Subject: ISSUANCE OF AMENDMENT NO. 45 TO FACILITY OPERATING
LICENSE NPF-21 - WPPSS NUCLEAR PROJECT NO. 2 (TAC 64987)

WPPSS Nuclear Project No. 2
(WNP-2)

Amendment No. 45
License No. NPF-21

SUPPORTING AMENDMENT NO. 45 TO FACILITY OPERATING LICENSE NO. NPF-21

Maximum Average Planar Linear Heat Generation Rate (MAPLHGR) Versus BUNDLE AVERAGE EXPOSURE
ANF 8x8 Reload Fuel
 Figure 3.2.1-6

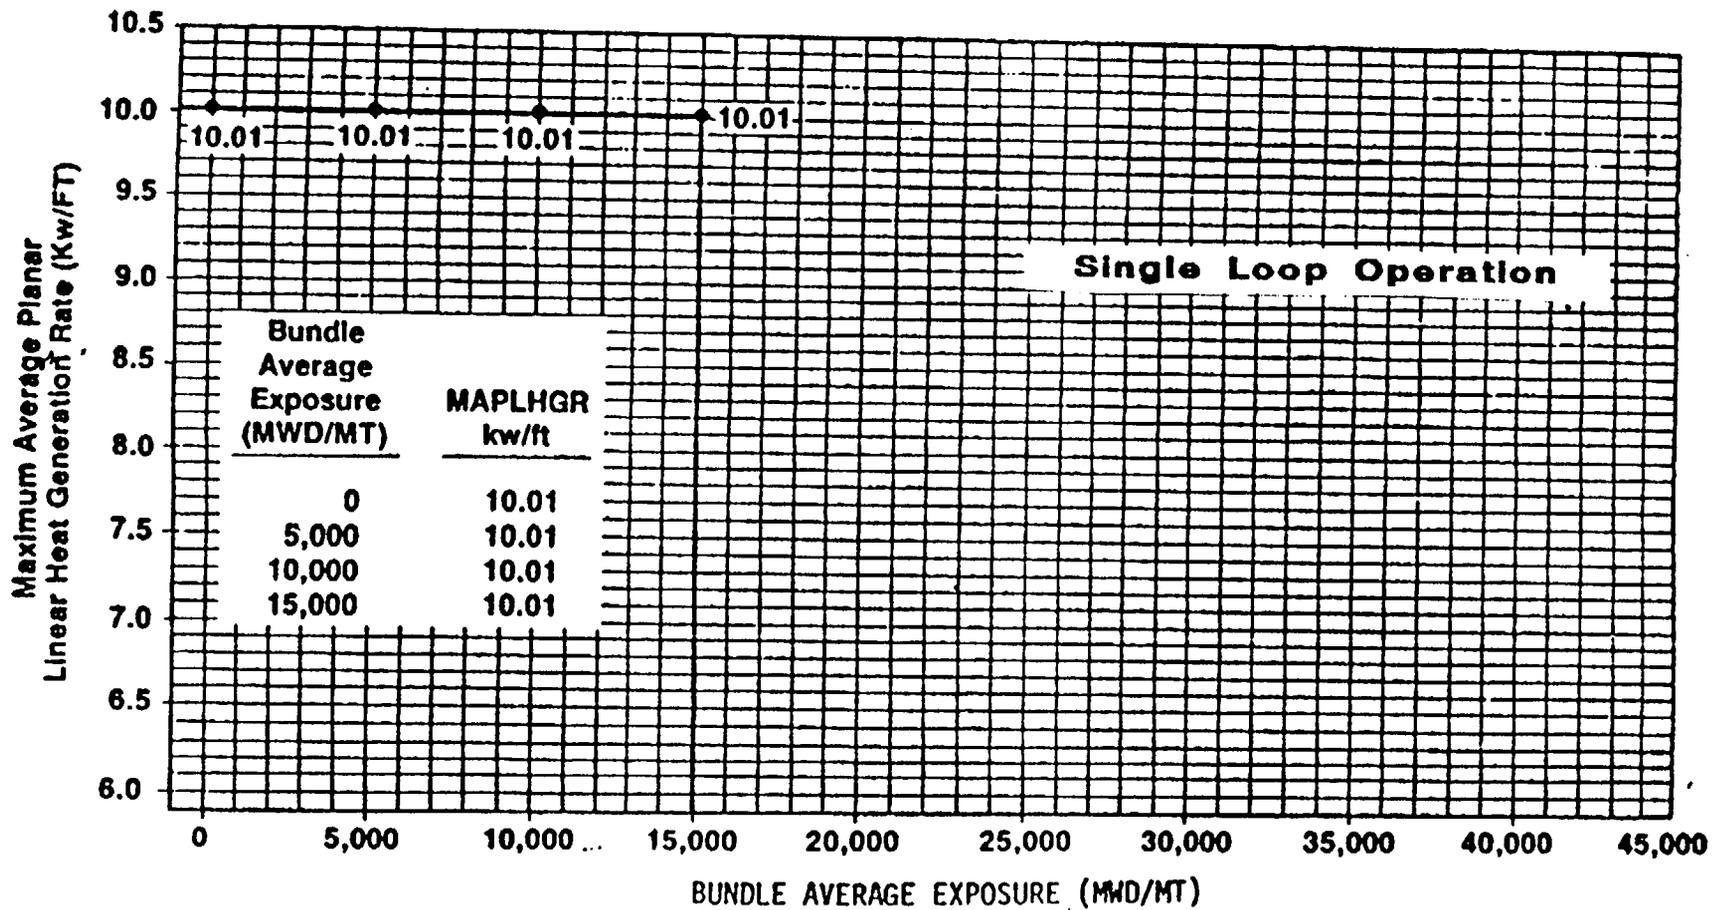
(1) Bases pages B 2-1 and B 2-2, Limiting Conditions of Operation (LCO) pages 3/4 1-8 and 3/4 2-1, Figure 3.2.1-3 on page 3/4 2-4, Figure 3.2.1-6 on page 3/4 2-4C, LCO page 3/4 2-9, Figure 3.2.4-1 on page 3/4 2-10, and Bases pages B 3/4 1-2, B 3/4 2-3 and B 3/4 7-4: Changes were made to reflect the corporate change from Exxon Nuclear Company (ENC) to Advanced Nuclear Fuel (ANF) Corporation, to identify the new fuel designation from ENC XN-1 to ANF 8x8C and to incorporate editorial changes. A reference to the approved thermal margin methodology report, XN-NF-84-105(A) was added. These changes are administrative only and have no safety significance, and are, therefore, acceptable.

Thermal Power Limits of Specification 3.3.10-1
Figure 3.3.10-1

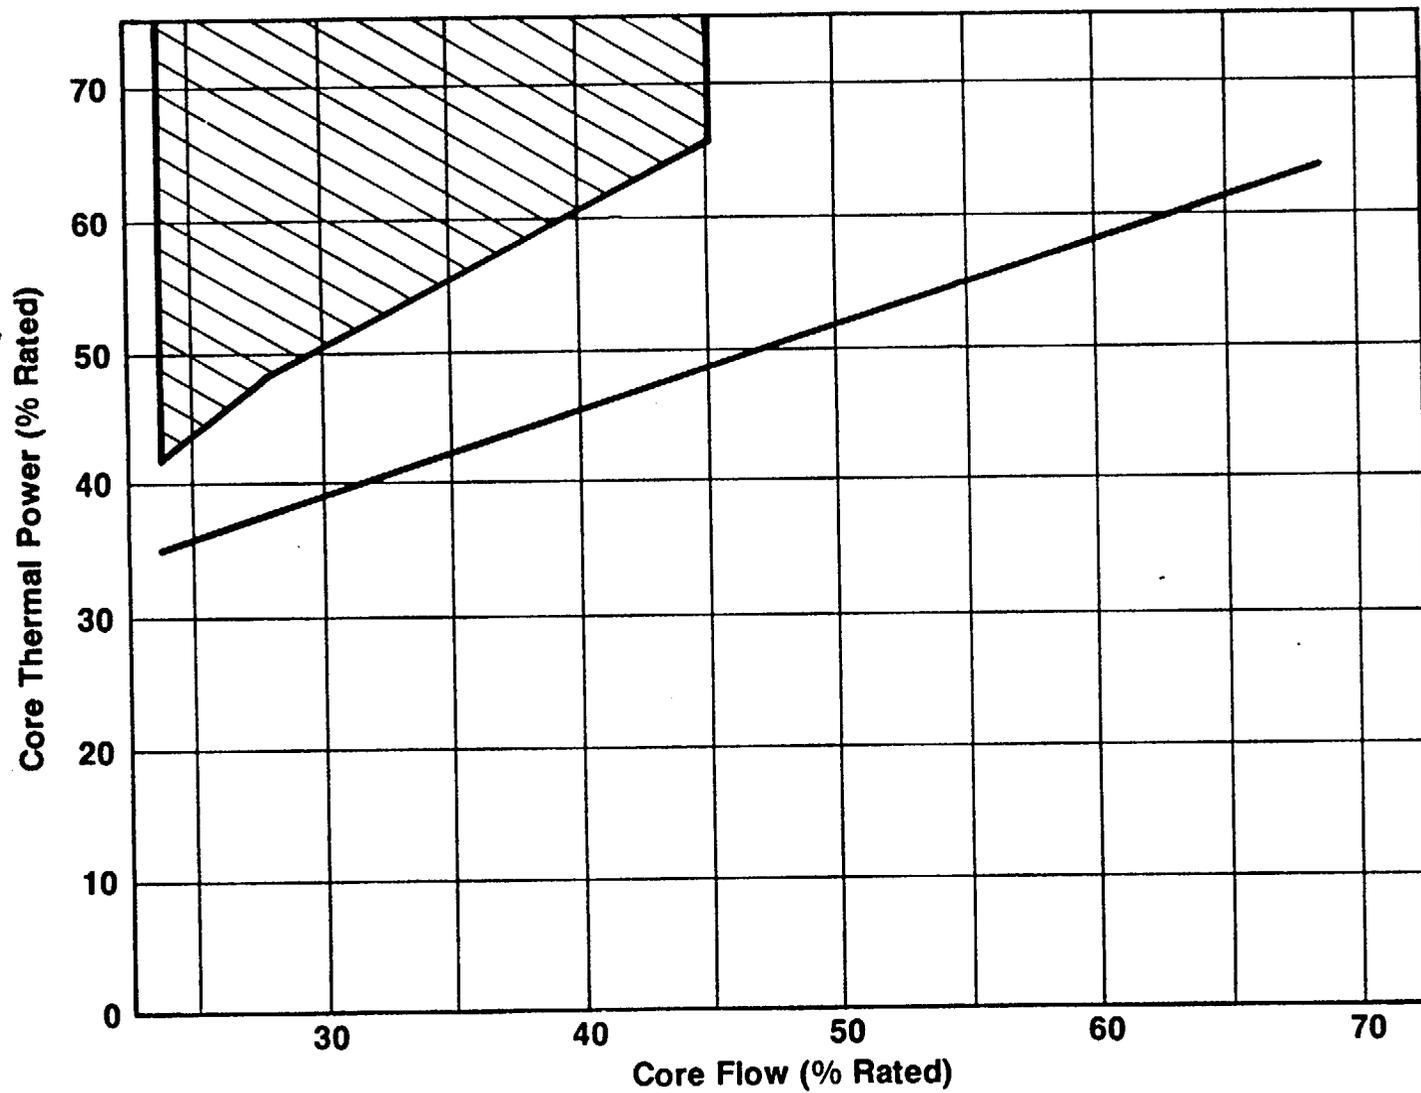
(3) LCO page 3/4 - 102: An ACTION statement (b) was added which states:

With reactor power/core flow in the crosshatched region of Figure 3.3.10-1, initiate corrective action within 15 minutes to reduce power by control rod insertion to a reactor power/core flow below the crosshatched region within 2 hours."

(4) Section 4.3.10.4, page 3/4 3-103: A phrase was added to the surveillance requirement for SLO to require that the reactor power/core flow shall be verified to lie outside the crosshatched region of Figure 3.3.10-1. This is a companion requirement to the additional statement in item (3) above to identify the region for corrective action. The addition is acceptable.
